SUTHERLAND SHIRE COUNCIL ASSESSMENT REPORT

Panel Reference	PPSSSH-84
DA Number	DA21/0629
LGA	Sutherland Shire
Proposed Development:	Demolition of existing structures and construction of a mixed use development, new bowling club facility with two bowling greens and 4 lot Stratum subdivision
Street Address:	101 to 109 Willarong Road, Caringbah (Lots 1 and 3-7 in DP 31460, Lot P in DP 413007, Lots 1 and 2 in SP 85329)
Applicant/Owner:	Caringbah Bowling & Recreation Club Ltd
Date of DA lodgement	6 July 2021
Number of Submissions:	Eight submissions
Recommendation:	Approval
Regional Development Criteria (Schedule 7 of the SEPP (State and Regional Development) 2011	This application is referred to the Sydney South Planning Panel (SSPP), as the development meets the criteria under Schedule 7.2 and 7.5(b) of State Environmental Planning Policy (State and Regional Development) 2011.
List of all relevant s4.15(1)(a) matters	<ul style="list-style-type: none"> • State Environmental Planning Policy (Affordable Rental Housing) 2009 (ARH SEPP) • State Environmental Planning Policy No. 65 – Design Quality of Residential Flat Development (SEPP 65) • State Environmental Planning Policy No. 55 – Remed

Figure 7: 16m height blanket with protruding portions of the building above the maximum permitted building height shown in white.

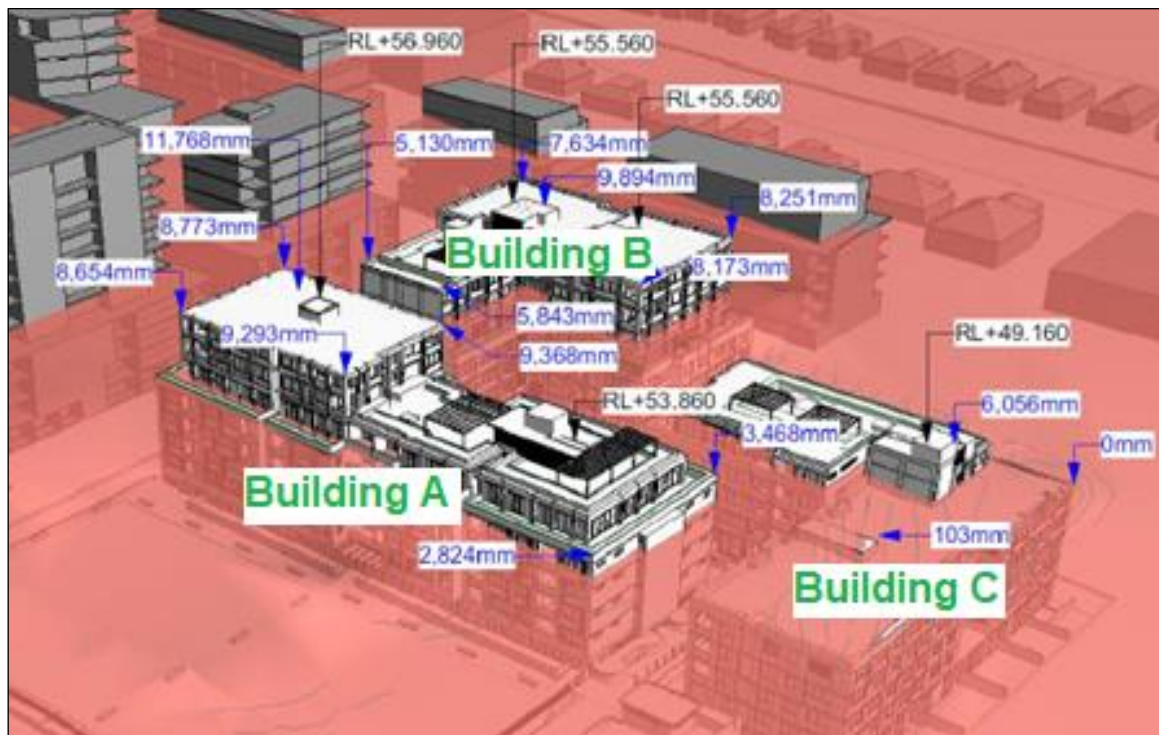
The proposed development fails to comply with the development standard for height. Clause 4.3(2) of SSLEP 2015 stipulates a maximum building height of 16m for this site. All three proposed buildings exceed the maximum building:

- Building A - 27.76m, representing a non-compliance of 11.76m (76.55%)
- Building B – 25.89m, representing a non-compliance of 9.89m (61.8%)
- Building C – 22.05m, representing a non-compliance of 6.05m (37.85%)

Building A is eight storeys in height, with the eighth storey confined to the southern side of the building. The tallest point on the building is a lift overrun. The bulk of the seventh storey is primarily confined to the southern side of the building where four apartments are proposed with a rooftop communal open space extending northwards to occupy approximately 60% of this storey and is slightly lower in building height. The sixth storey also protrudes above the maximum permitted 16m building height development standard and has a floor plate that is slightly recessed from levels directly below. At the fifth storey, a minor protrusion above the permitted 16m building height occurs at the northern edge of Building A due to the topography of the land.

Figure 13: Level of obstruction to solar access gained to built form approved on No. 113 Willarong Rd at 11am midwinter.

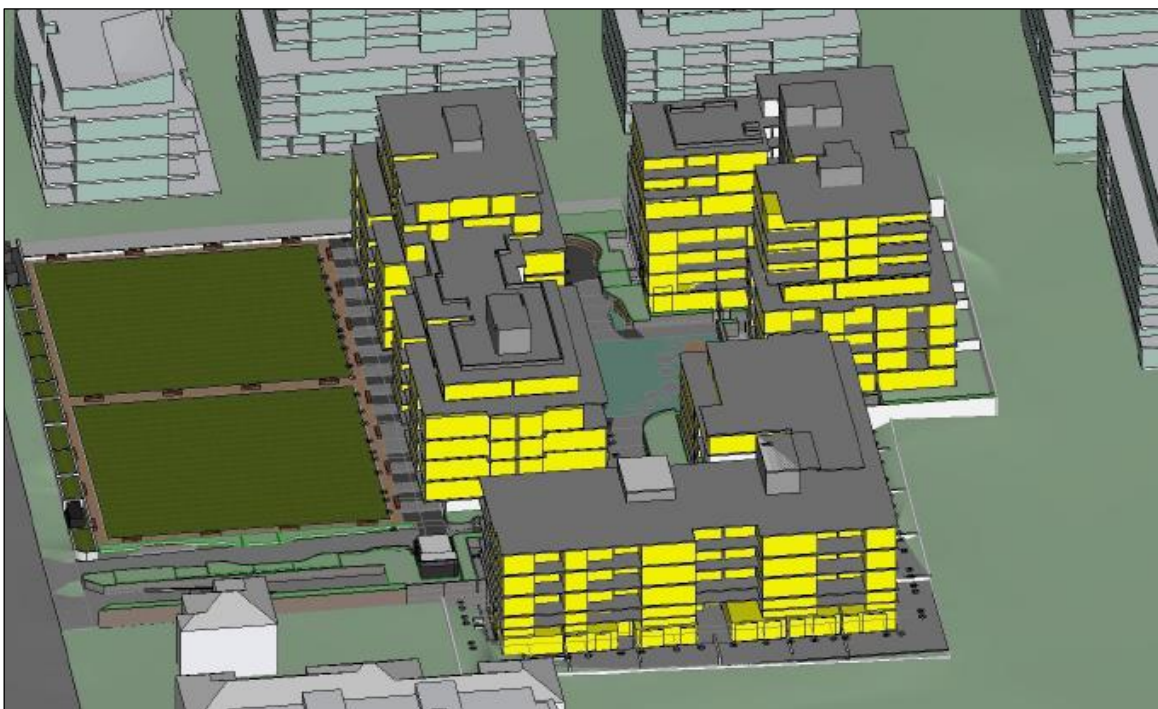
With regards to overshadowing, it can be foreseen that the lower levels of two buildings positioned to the south of Building A and B on No. 113 Willarong Rd will be partially impacted, with the most severe impact occurring at 11am midwinter as illustrated below:

This impact is intermittent but short lived. At 3pm midwinter, obstruction to solar access moves to other portions of the building so the impact will not relate to the same apartment at all times of the day. It must also be accepted that No. 113 Willarong Rd is situated to the south so it is inevitable that overshadowing will occur, even with a compliant built form, which may see a wider built form within the 16m height envelope and consequently cause overshadowing to become wider and fall within individual apartments longer.

Figure 14: Northern elevation of Building A, where high sill windows are proposed that cause a non-compliance for building separation.

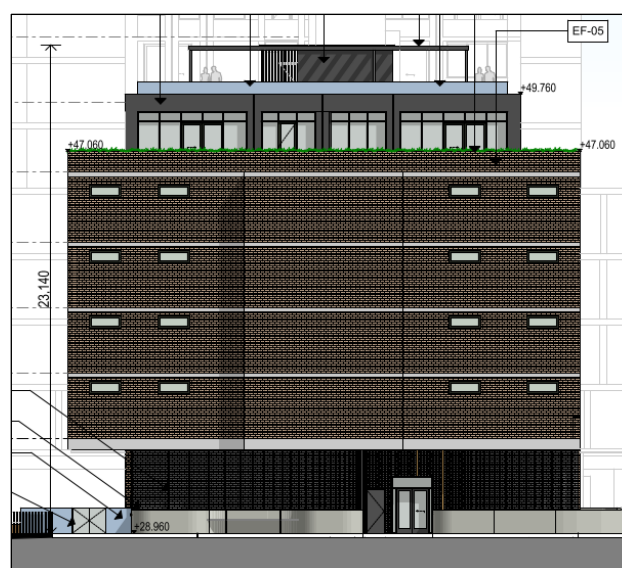
Between levels 1 and 3 (2nd to 4th storey) extending in a north-south direction, a 9m setback exists where a 12m setback is prescribed by the ADG. The distance is applied as a high sill window is positioned along a northern wall of Building A to maximise opportunities for sunlight.

The high sill height relieves privacy issues between apartments on the same level but as overlooking from apartments on a higher level within Building C, a design change condition is recommended for these windows to have a slight 'hood' of between 200-400mm protruding above the window to avoid this downward, directional overlooking.

Figure 15: Building separation at level 4 (5th storey) – 18m required.

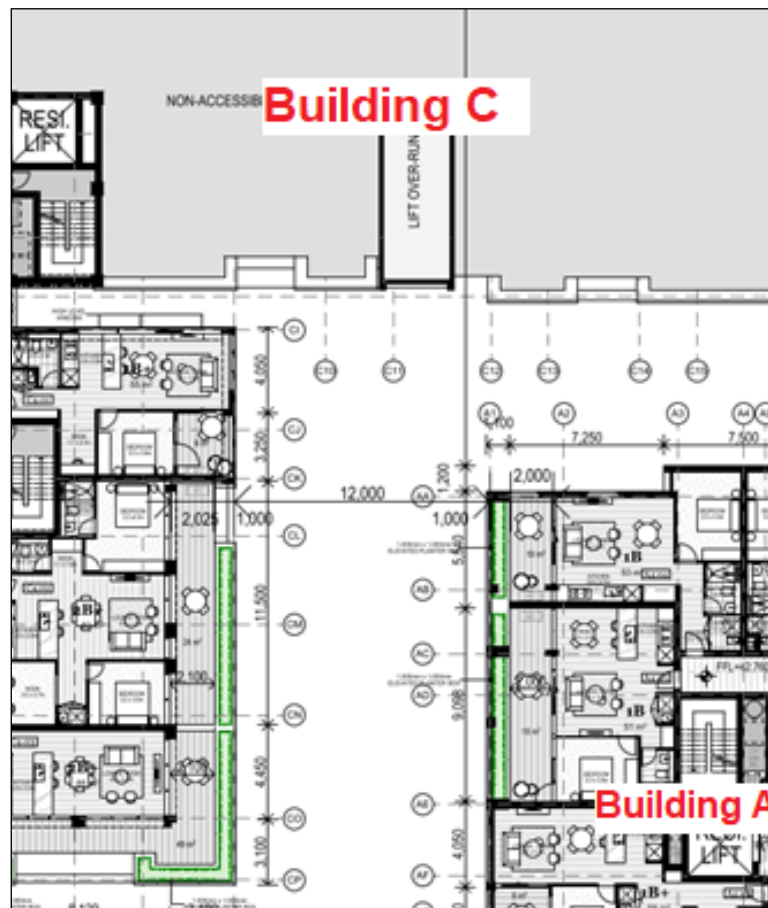
Between each building's level 4 (5th storey) extending in an east-west direction, a 12m setback is proposed. A 18m is required to accord with the ADG. This represents a variation of 6m and is shown in the plan extract below:

While provision of a planter box aids privacy through screening and the floor levels are offset from each other (Building A is set at RL42.76 while Building C is RL41.58), these are all the measures which can be applied to the design for the apartment shown in the plan extract above within Building A. While desirably the one bedroom apartment in the north-western corner of Building A shown in the extract above would greatly benefit from being re-orientated to the north to capitalise on a district view and sunlight, the apartments narrowness restricts the layout of the space from working successfully.

Figure 16: Building separation at level 1-3 (2nd to 4th storey) – 12m required.

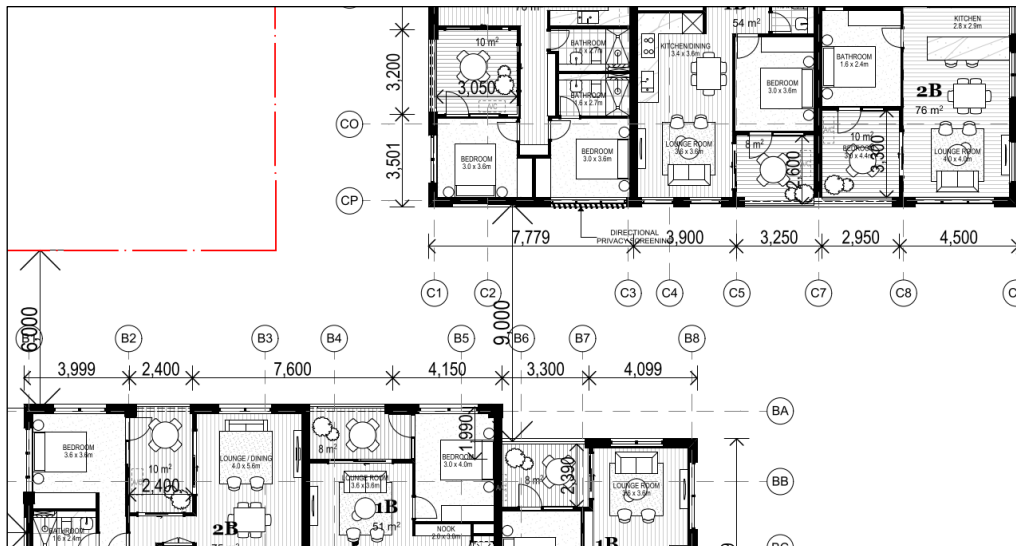
A 7.5m separation distance is proposed at level 1 to 3 (2nd to 4th storey) where 12m is required, representing a non-compliance of 4.5m. The portion of the building in which this distance occurs is minor, with the distance widening to 9m to represent a 3m separation.

For the majority of the non-compliance, the separation occurs with a bedroom which is seldom used aside from sleeping purposes.

Figure 17: Building separation at level 4 (5th storey) – 18m required.

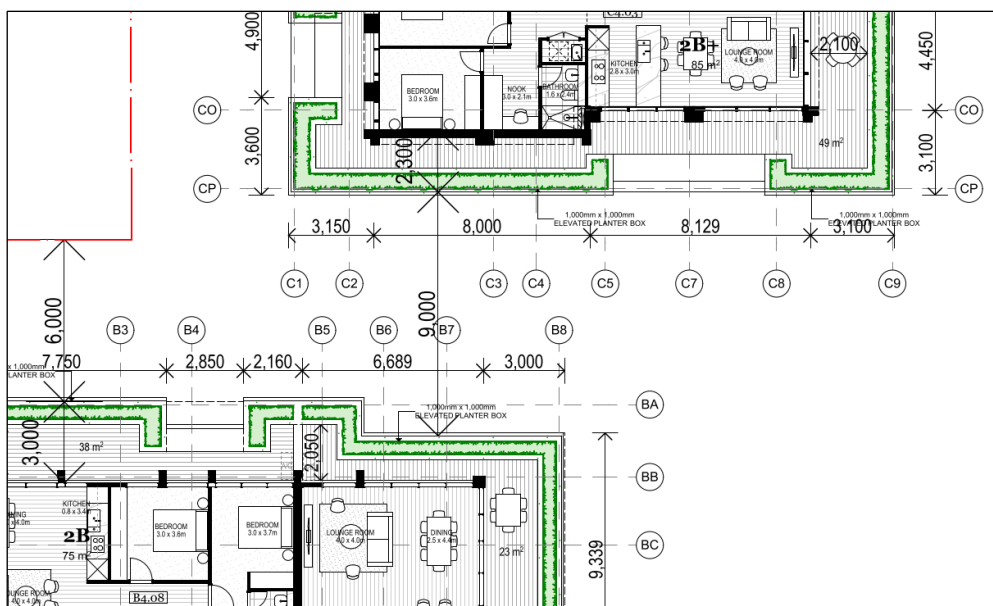
This non-compliant building separation continues at level 4 (5th storey), however the distance relates to balconies only – each being edged with a planter box as shown below:

Figure 17: 15m height of 6m setback applied to north-eastern corner of Building A (or 16m when including parapet), measured to No. 99 Willarong Rd and No. 97 Willarong Rd.

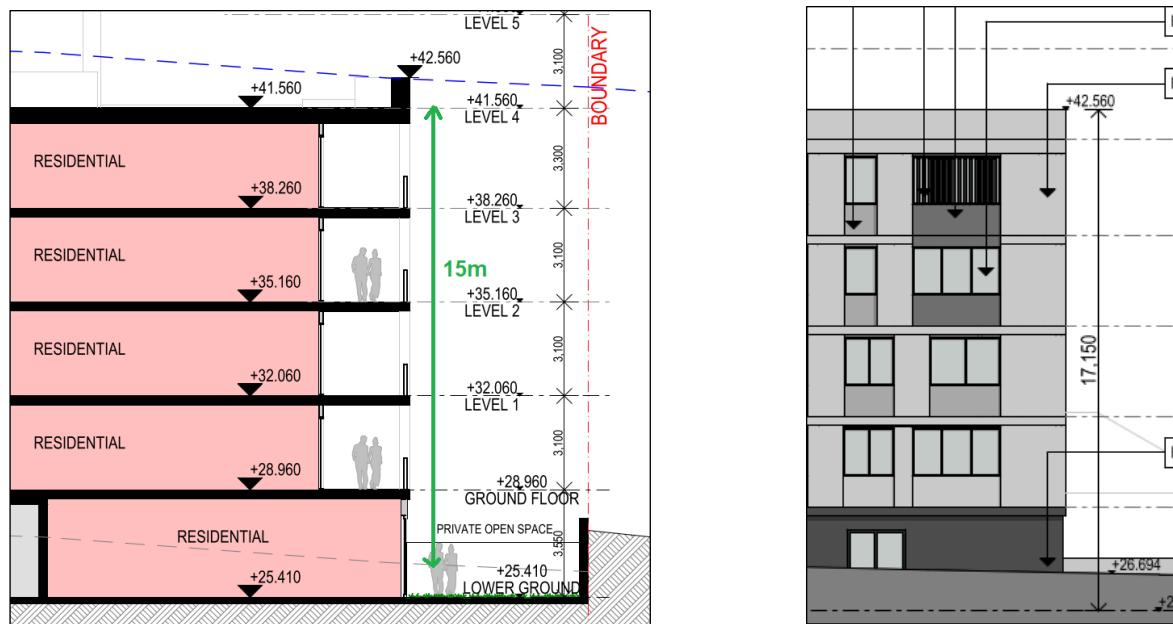
With regards to the setback in the north-eastern corner of Building A, the application of a 6m setback at level 3 (5th storey due to lower ground and ground floors being proposed) sees the building achieve this setback for 15m. The ADG prescribes that a 6m setback apply up to a height of 12m (4 storeys). This is illustrated below:

Figure 18: Apartment comparison with living area windows positioned at the rear of the balcony (2B apartment in plan extract) struggling to achieve 2 hours solar access.

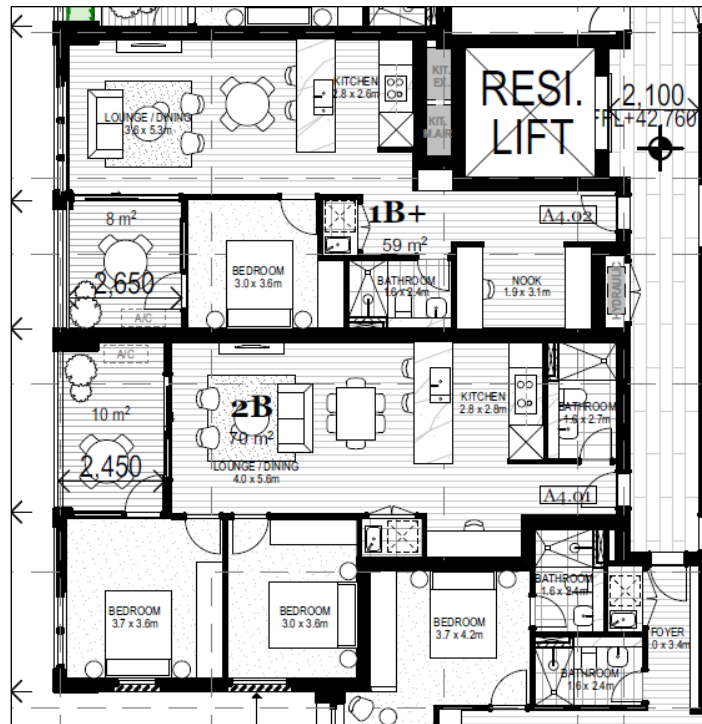
The ADG and SSDCP 2015 prescribe that 70% (171) of apartments achieve a minimum of 2 hours solar access to living areas and private open space. The proposal results in 57.3% (140) of apartments as compliant with this control. Many apartments comply with solar access to living areas but not their private open spaces. It is evident that apartments with living rooms accessed from the recessed part of the balcony struggle to comply such as A4.02:
